COUNTRY CLUB DRIVE PAVEMENT REHABILITATION

Addendum #2
Project 2018-34
Date: February 11, 2021

ADDENDUM NO. 2

ADDENDUM NO. 2, 02/11/21
COUNTRY CLUB DRIVE PAVEMENT REHABILITATION
PLAN SHEET 3, DETAILS

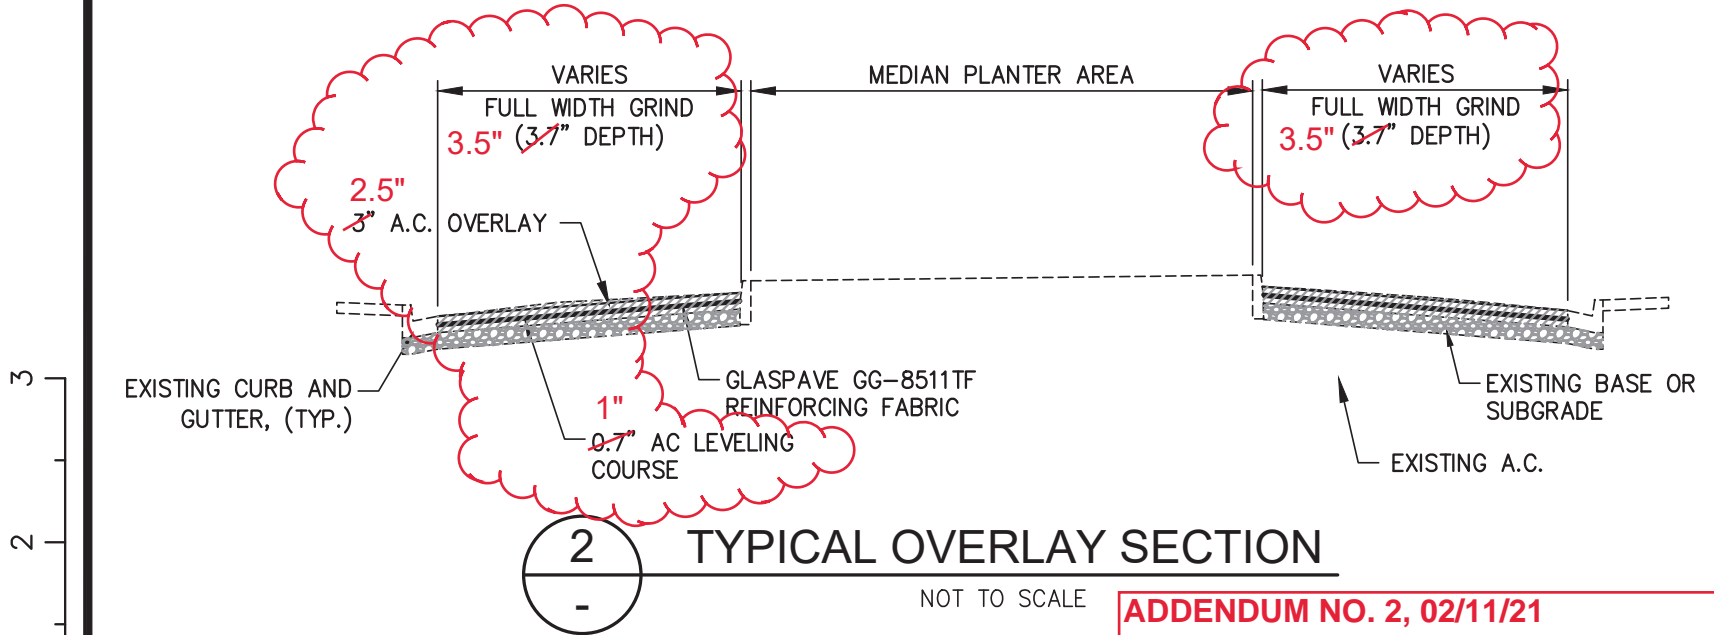
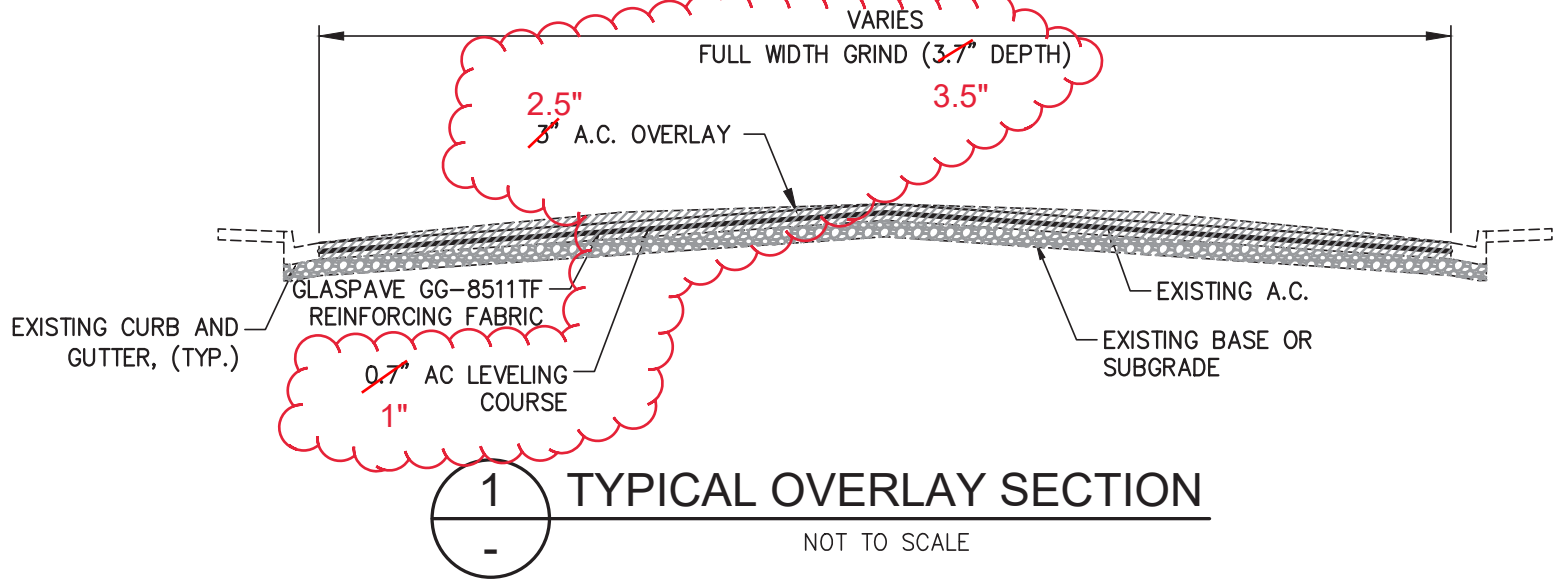
1. CHANGE TO: PROJECT PLANS, PLAN SHEET 3 OF 16, DETAILS, Typical Overlay Sections 1 and 2 shall be revised as per attached drawing.

TYP OVERLAY SECTION CHANGES
